Report to the Future Melbourne Committee

Planning Permit Application: TP-2022-229 6-10 MacArthur Place North, Carlton

4 April 2023

Application number:	TP-2022-229
Applicant:	Tract Consultants
Owner:	Mr John Peter Piccolo
Architect:	DP Toscano Architects Pty Ltd
Address:	6-10 MacArthur Place North, CARLTON VIC 3053
Proposal:	Partial demolition, external alterations, and buildings and works to construct three dwellings on a lot
Cost of works:	\$985,000
Date of application:	4 May 2022
Responsible officer:	Rochelle Fleming, Senior Urban Planner

Figure 4 – Key material changes between plans considered at VCAT and current proposal

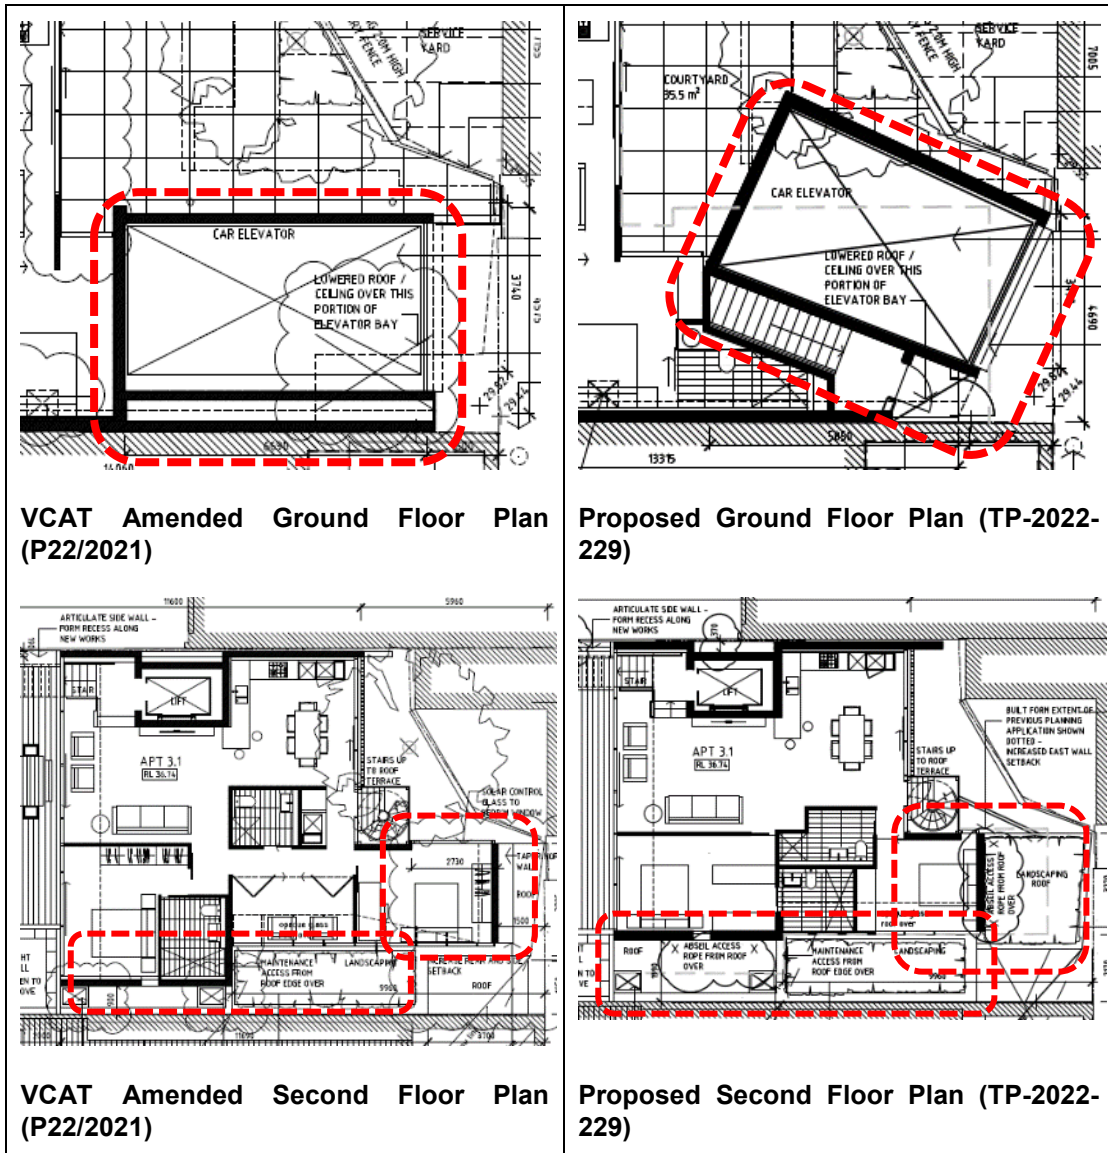
- Roof terrace setback from eastern boundary increased from 3.325 metres to 3.565 metres.
- Swing of the retained two ground floor front doors to 6 and 8 MacArthur Place North changed to also open inwards.
- Small west facing window added to extension to provide window to Study of Apartment 2.
- Landscaped roof added to flat roofs at first and second floors.
- A change to the roof balustrade material from dark grey to lighter grey cladding.

Figure 6 – Swept path diagrams demonstrating entry to car parking spaces

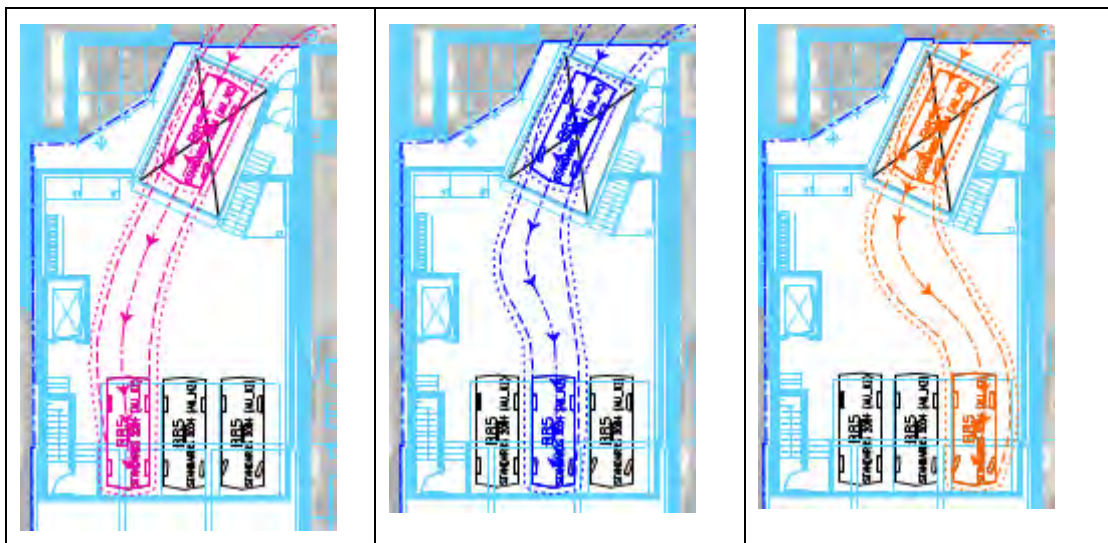
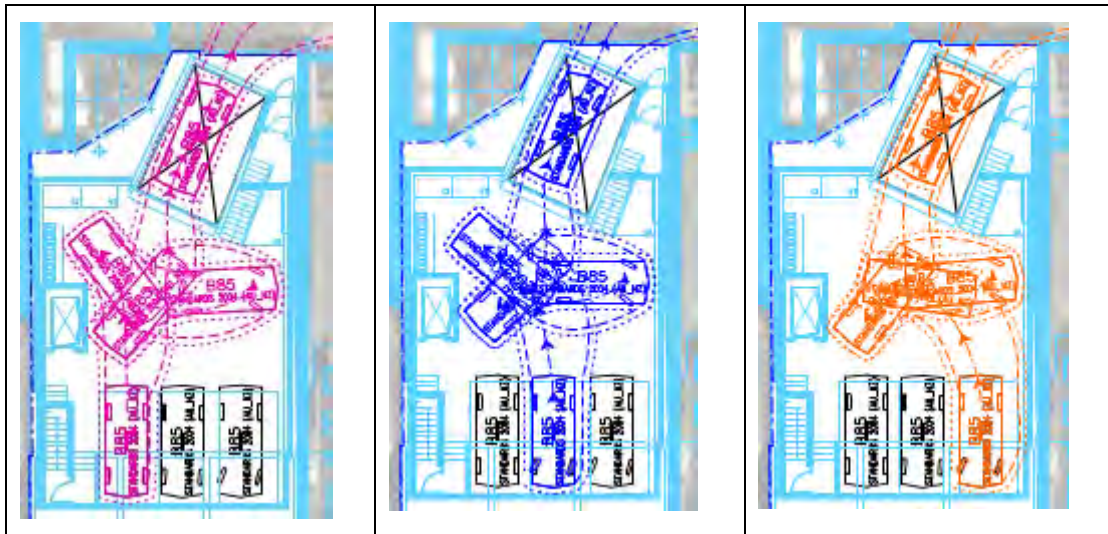
The application is supported by a Transport Impact Assessment and supporting swept path diagrams. The amended proposal incorporates a larger car lift, set on an angle from Nicholls Lane. This arrangement results in an improved access to the basement car spaces, with all spaces accessible with a single manoeuvre for entry and a single correction manoeuvre for exit. This is demonstrated in the submitted swept path diagrams.

A 'corrective manoeuvre' is permitted under the relevant standards in AS2890.1:2004 for residential car parking. As such, the key consideration is the Decision Guidelines of Clause 52.06-10 of the Melbourne Planning Scheme. The key relevant decision guideline in this instance is the requirement to consider *"the ease and safety with which vehicles access and circulate within the parking area"*.

Figure 8 – Swept path diagram for entry for B99 vehicle

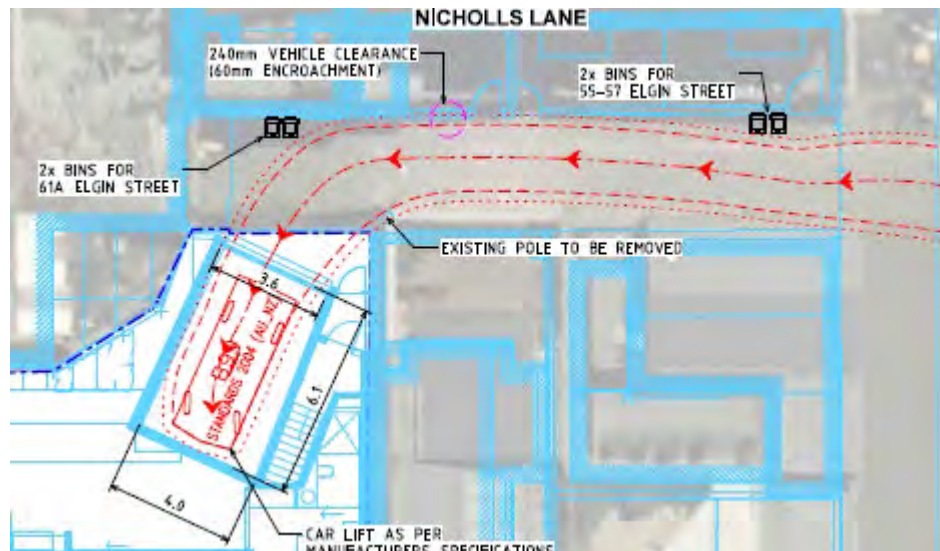
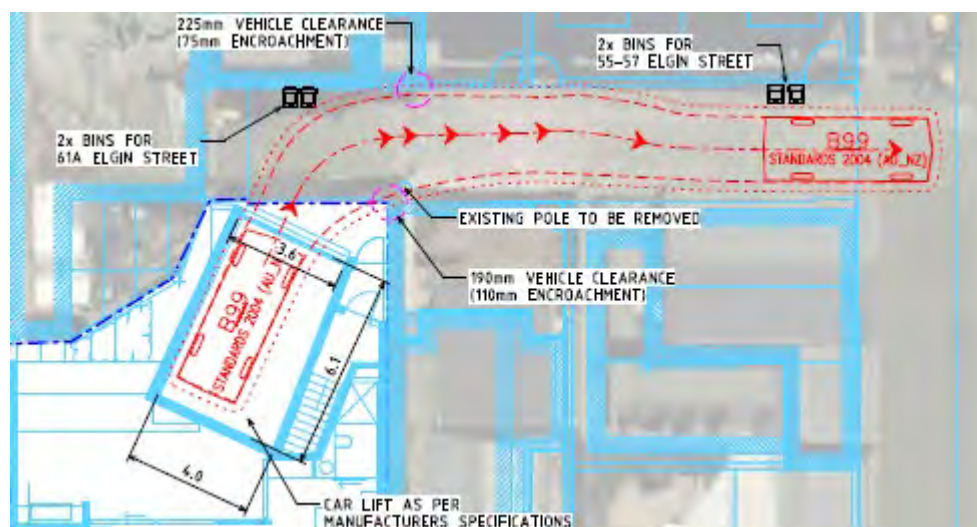
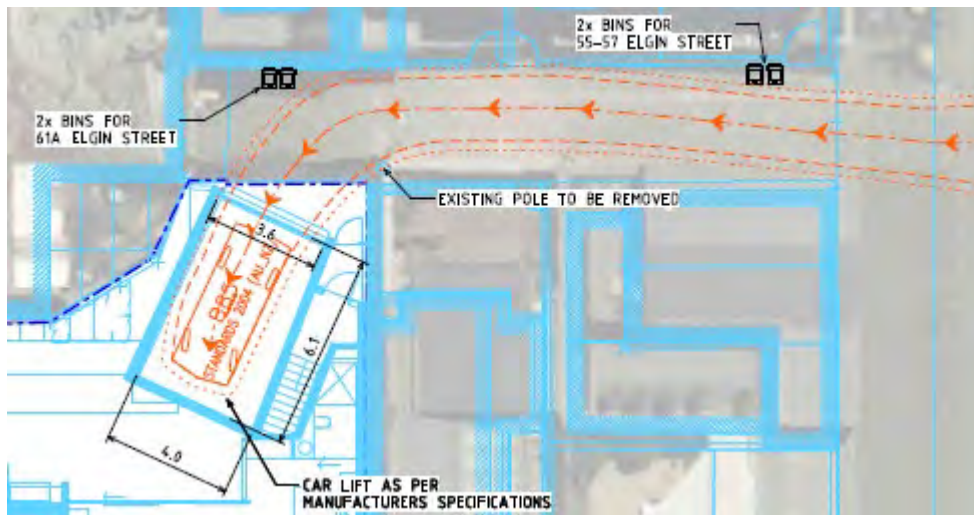
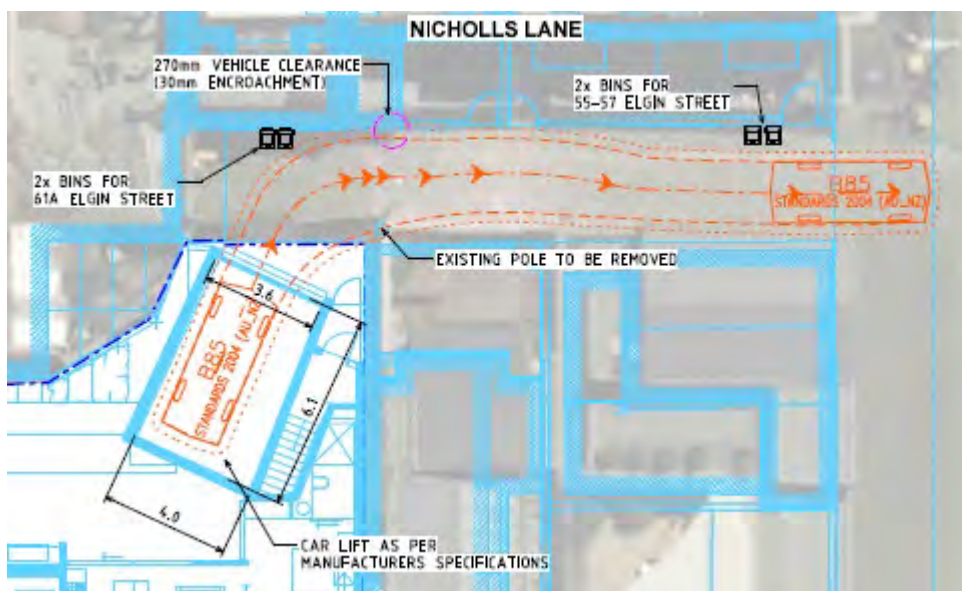
The swept path diagrams show that for entry into the car lift by a B99 vehicle there would be a 240 mm vehicle clearance to the southern boundary wall of 59 Elgin Street. For the exit manoeuvre there would be a 225 mm vehicle clearance to the same wall and a 190 mm vehicle clearance to the north-western corner of 4 MacArthur Place North. For B85 vehicles, there will be a 270 mm vehicle clearance to the southern boundary wall of 59 Elgin Street for the exit manoeuvre.

Figure 13 – Overlooking diagram provided by the permit application from the proposed roof terrace

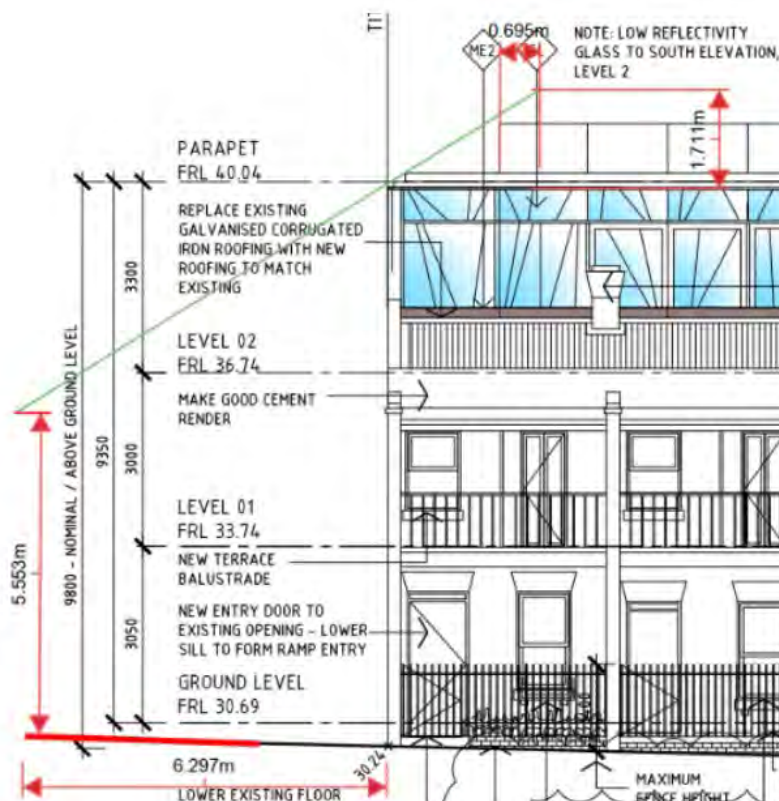
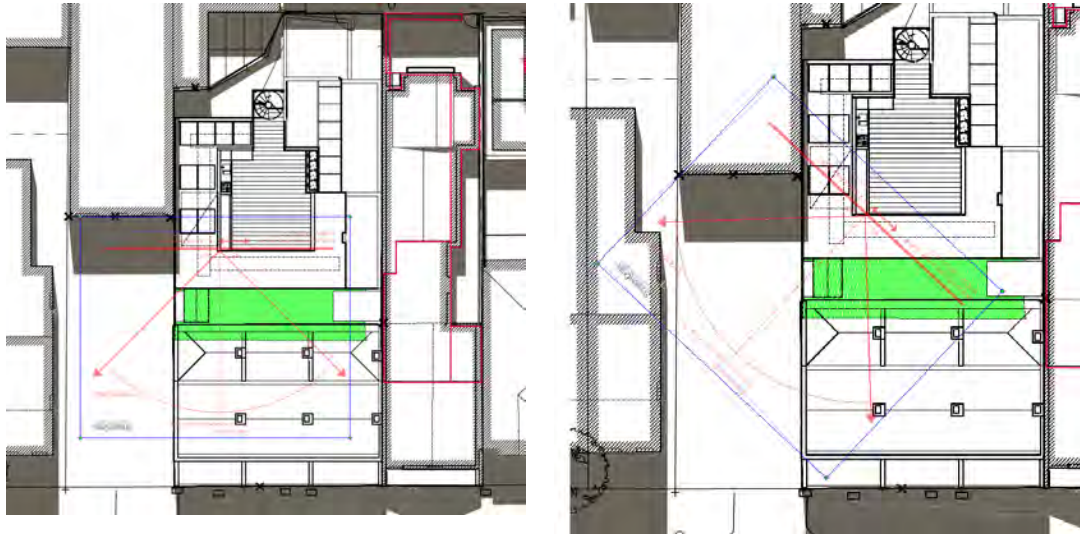
The permit applicant has submitted a diagram demonstrating that the roof of the built form below would obscure views of the secluded private open space of 14 MacArthur Place North. Visibility from the roof terrace would be approximately 5.5 metres above natural ground level at 14 MacArthur Place North which is well above ground level of the SPOS associated with 14 MacArthur Place North. As demonstrated by Figure 14 below, there would also be no views from the roof terrace when looking south as the windows and SPOS of 14 MacArthur Place North is outside the 9 metre overlooking radius.

As such, this VCAT concern is considered to be resolved.

Figure 15 – Proposed sightlines

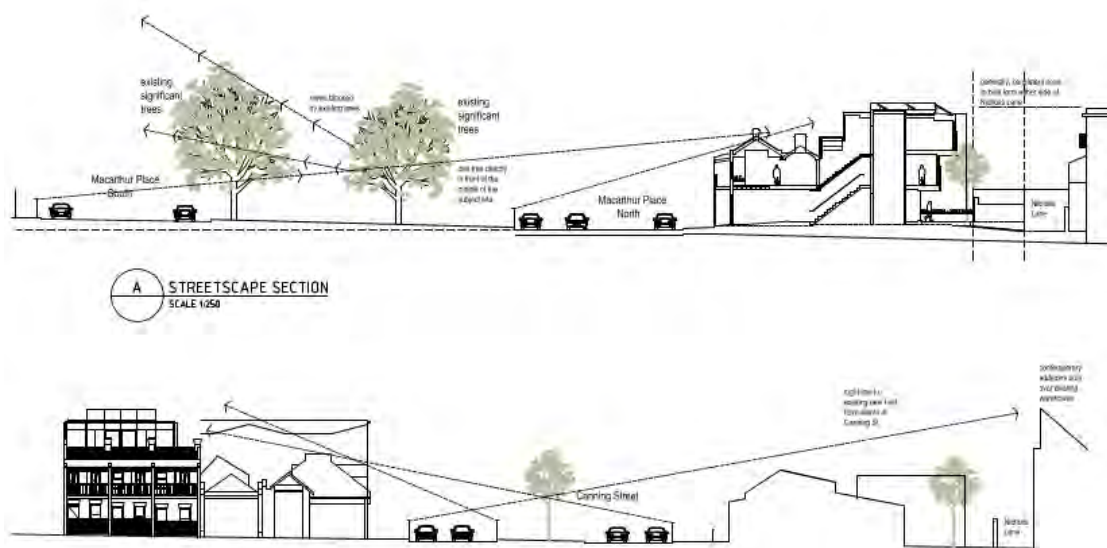
- The structure being setback from the eastern title boundary.
- The existing context which contains a two storey blank wall addition at the rear of 2 MacArthur Place North.

Figure 16 – Proposed Ground Floor Plan

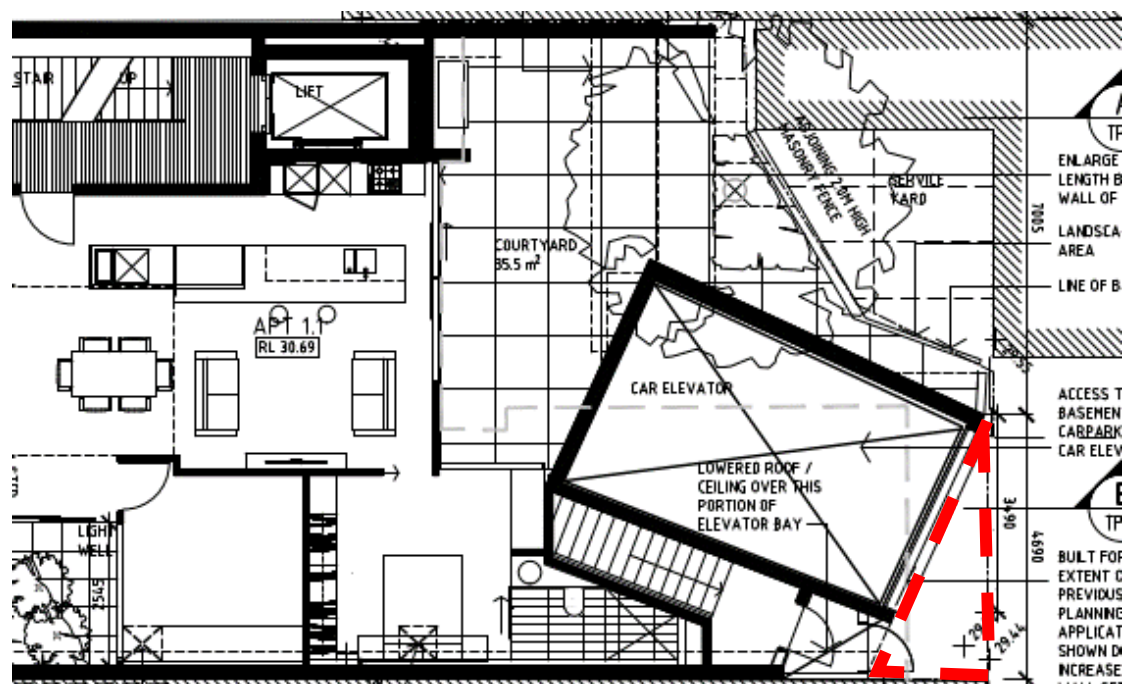
The applicant has also questioned whether this would be an unsafe place, on the basis that it is their view that where concealed entries are twice as wide as they are deep, there is sufficient visibility to avoid creating a place for ‘hiding’.

Landscaped roofs would not be easily accessible for maintenance
